Re: Warehouse Addition, 120 Morningside Dr. SE
Grading and Drainage Plan
Engineer's Stamp dated 9-7-06 (K17/D87)

Re: Warehouse Addition Grading Plan Certification
120 Morningside Dr. SE
Engineer Cert Stamp dated 9-21-09 (K17/D87)

**RE: WAREHOUSE ADDITION, 120 MORNINGSIDE DR. S.E.
(K17-D87)**

Re: Warehouse Addition, 120 Morningside Dr. SE
Grading and Drainage Plan
Engineer's Stamp dated 8-15-06 (K17/D87)

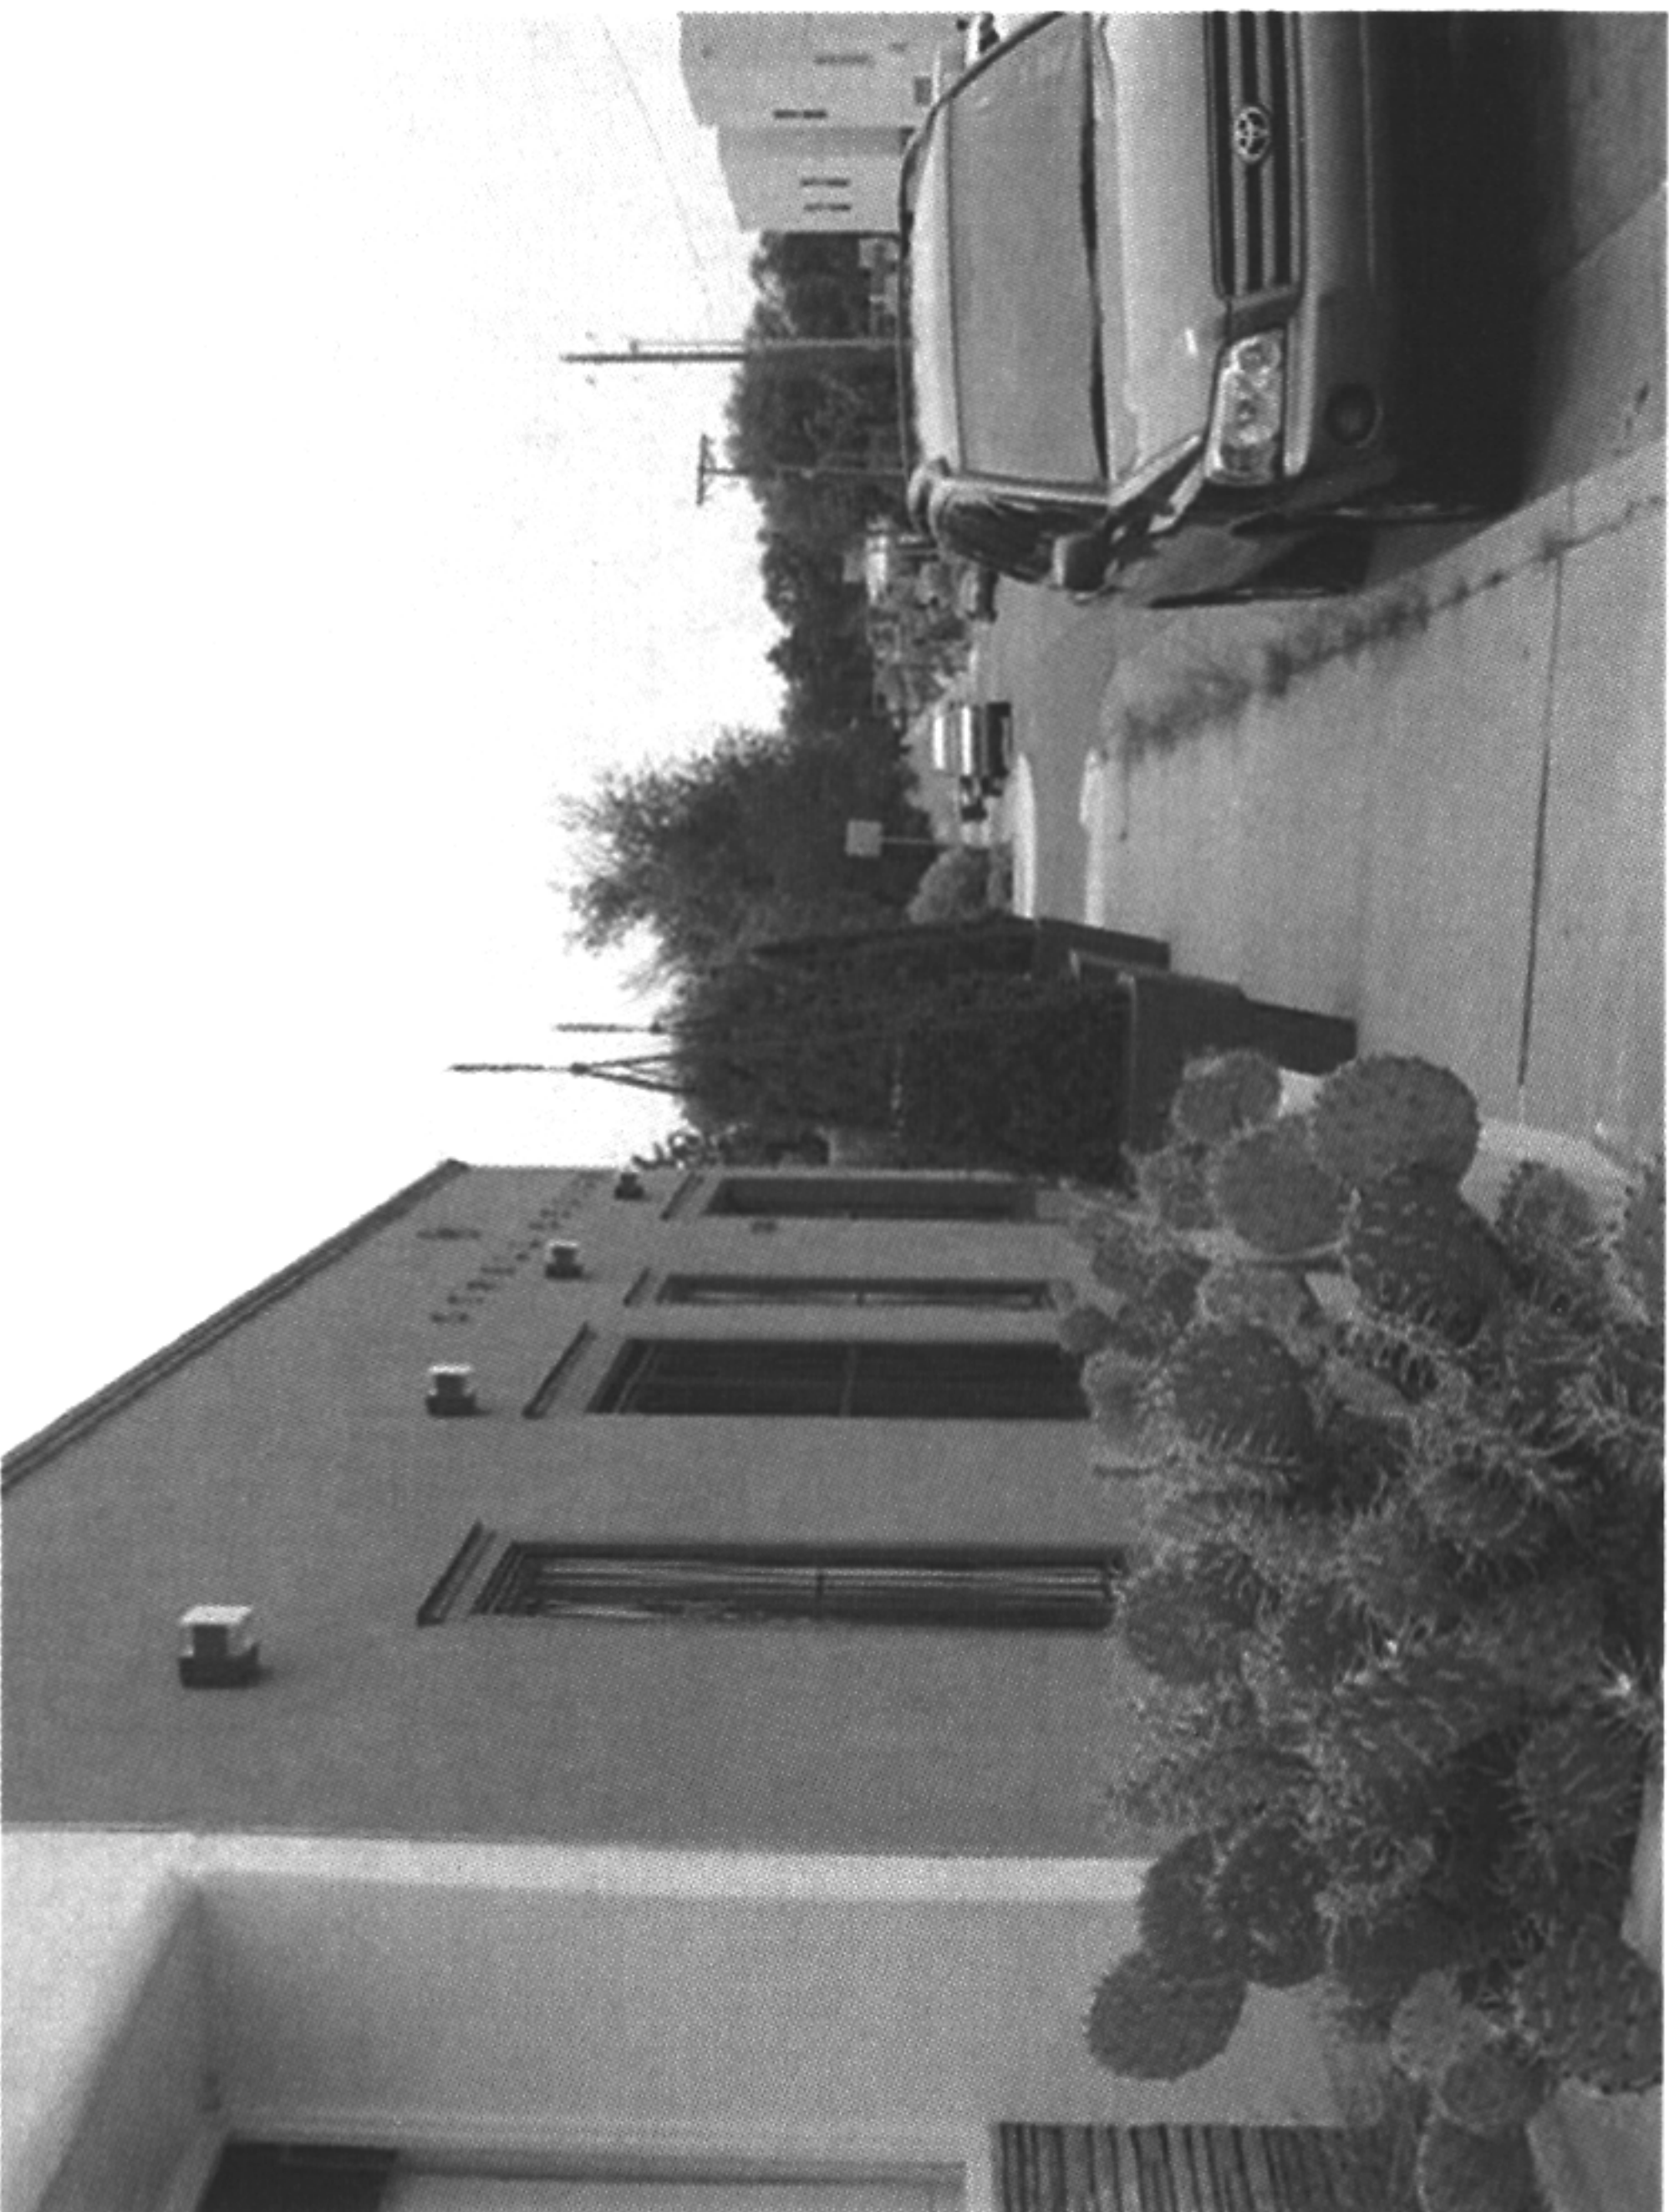
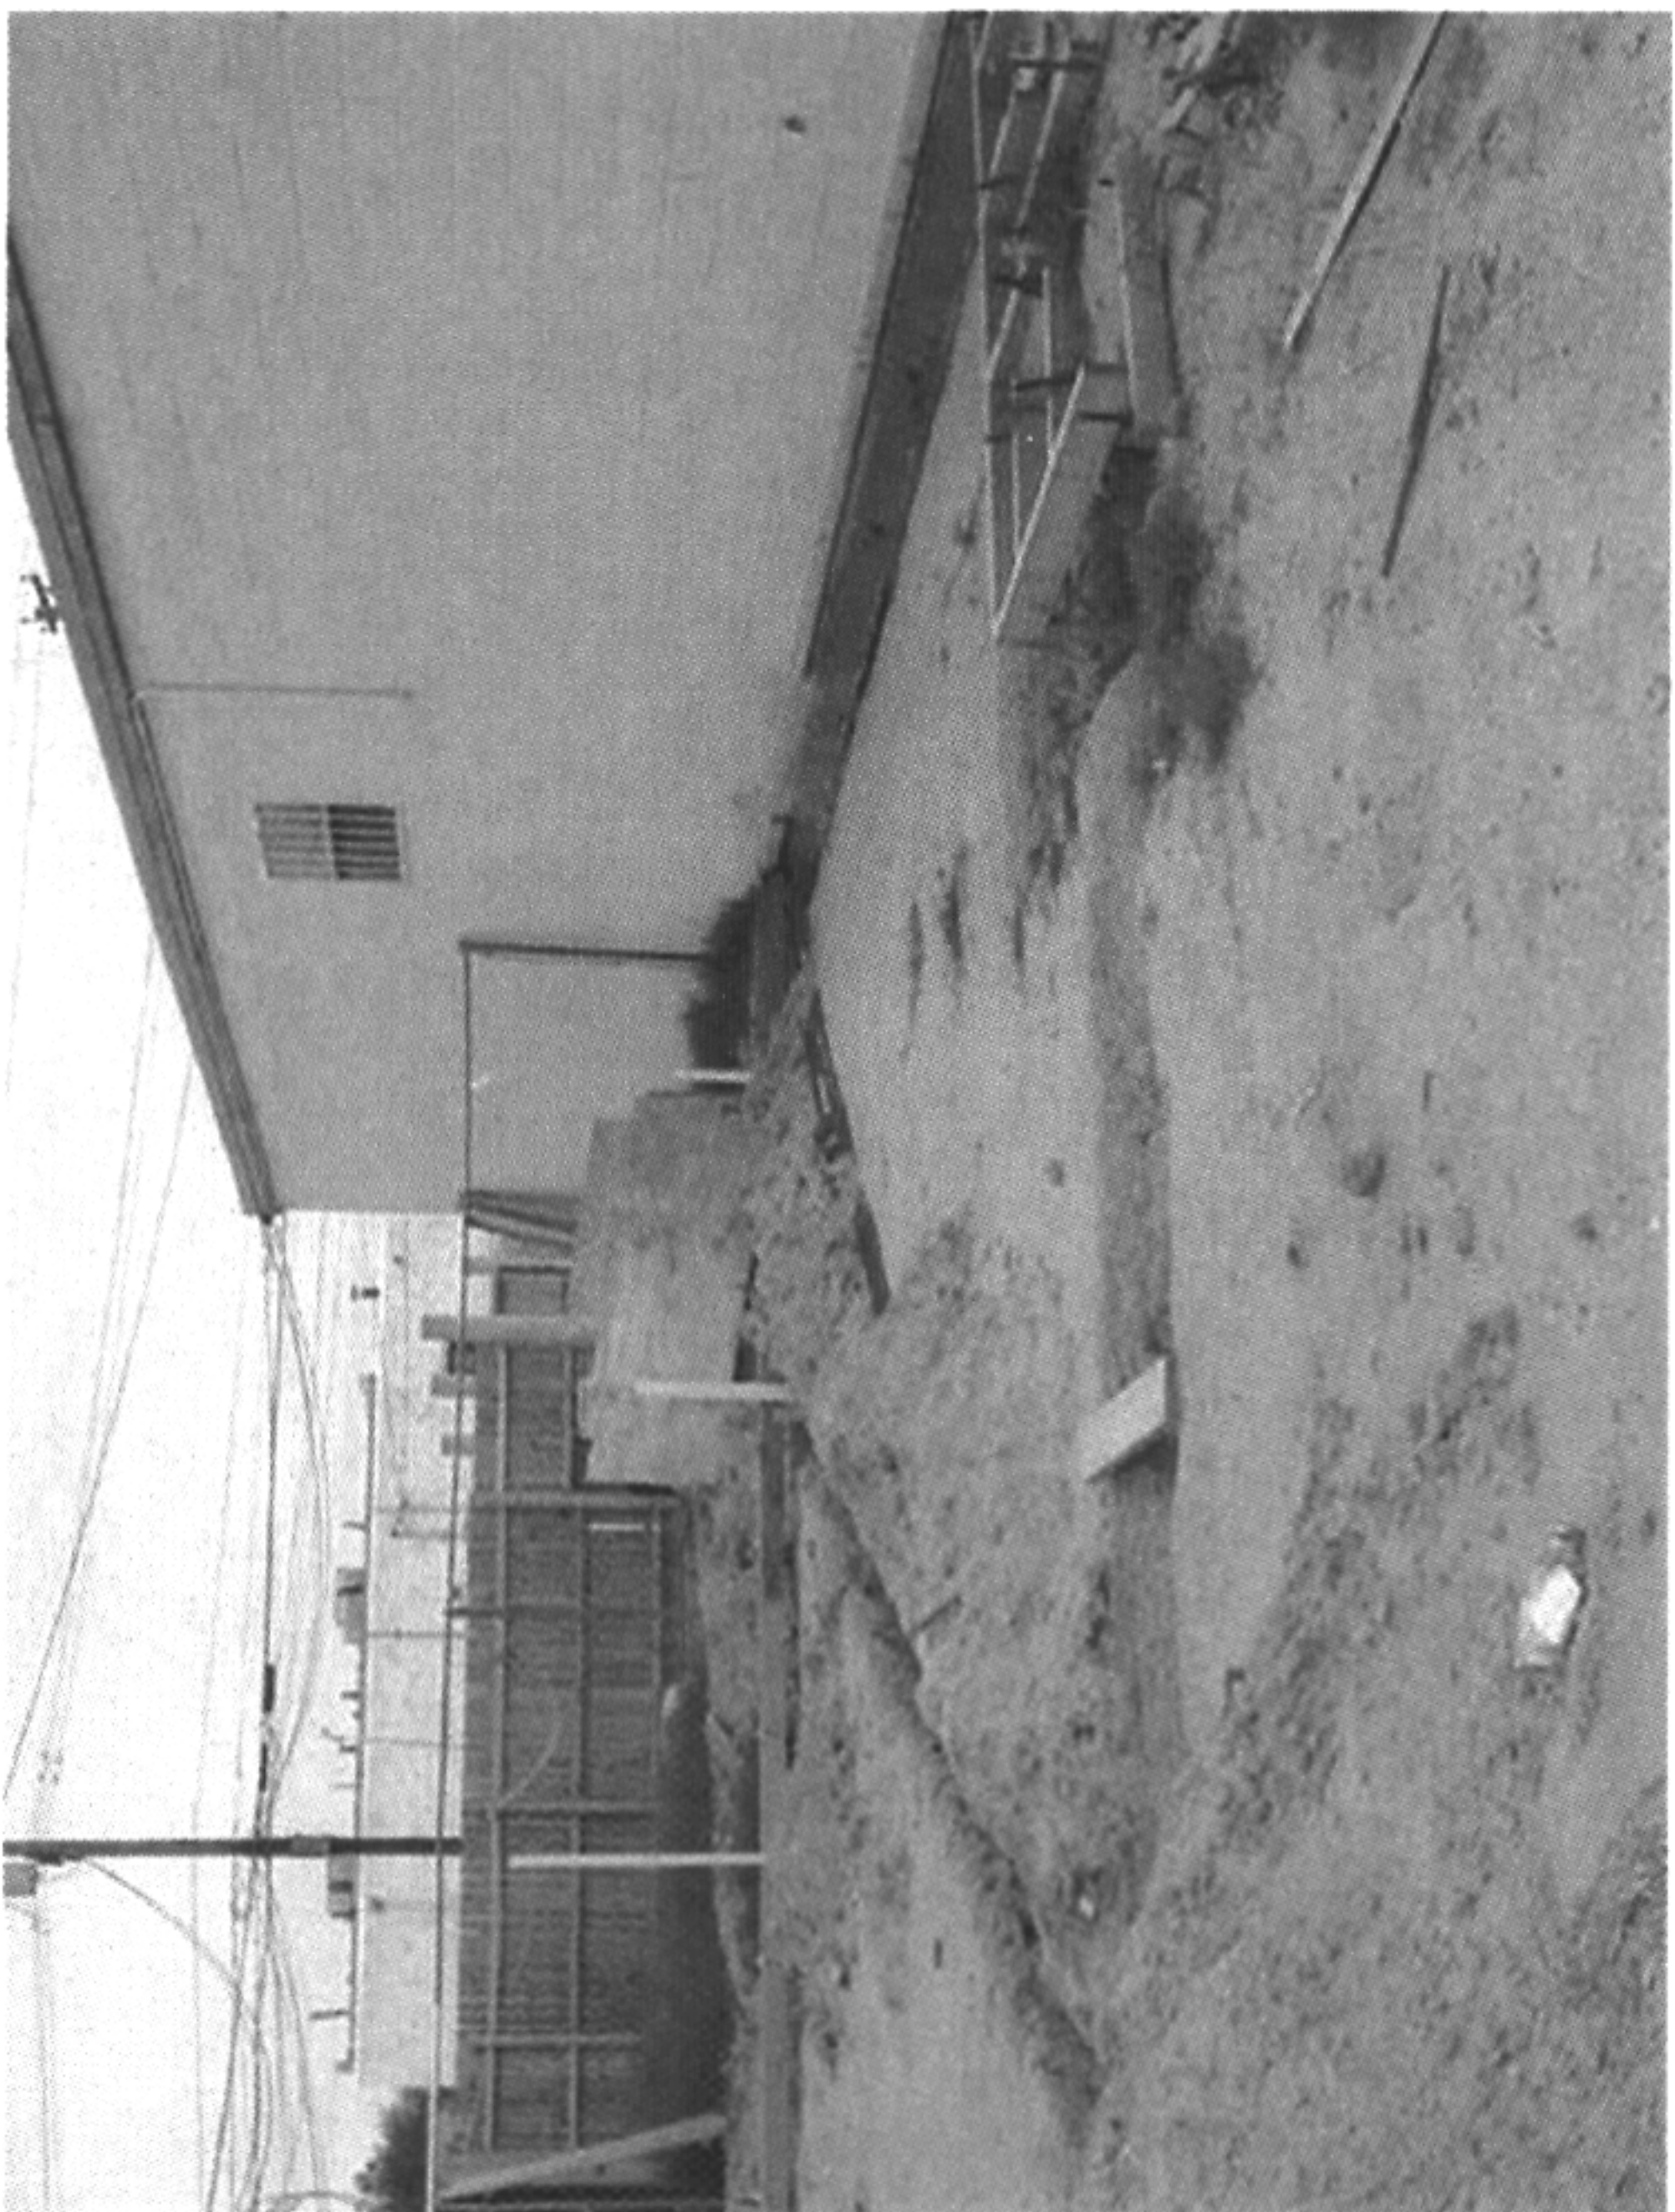
- The rundown in NE corner of the plaza was shown as deleted and this rundown is an integral feature of the drainage plan; it was needed to convey water away from the building. It is likely that water will pond adjacent to the addition and could cause issues with the foundation. If your client and the adjacent owner acknowledges this fact and will do so in writing, it could be allowed.

- Do any offsite flows enter this site? Provide existing spot elevations or contours for this site as well as the lot north of this site.
- Since the drivepad on Silver Ave. is no longer being used, it will have to be removed and new sidewalk and curb and gutter constructed. Drainage from the site will then be conveyed to Silver Ave. through a sidewalk culvert.
- How deep is the 12" concrete trough? Provide inverts for both ends.

~~Comments:~~ CURTIS, REVIEW AND SEE IF YOU CONCUR. I RAISED THE INVERTS AND I AM STILL BELOW THE FINISH FLOOR

1. Do any off-site flows enter the site? *No off-site flows enter the site from any direction. Note has been placed on the plan drawing.* Provide existing spot elevations or contours for this site as well as the lot north of the site. *Additional spot elevations have been inserted on the plan drawing for both the site and north of the site.*

2. Since the drivepad on Silver Ave. is no longer being used, it will have to be removed and new sidewalk and curb and gutter constructed. Drainage from the site will then be conveyed to Silver Ave. through a sidewalk culvert. *Two parking spaces have been designed to be located just south of the proposed building. A concrete trough will drain the roof run-off onto the new proposed asphalt within the parking spots. From that point it will drain out the existing drivepad. The existing drivepad will be utilized.*

3. How deep is the 12" concrete trough? *The proposed concrete trough will be 12" wide by 6" deep.* Provide inverts for both ends. *Inverts have been provided on the plan drawing for each end.*
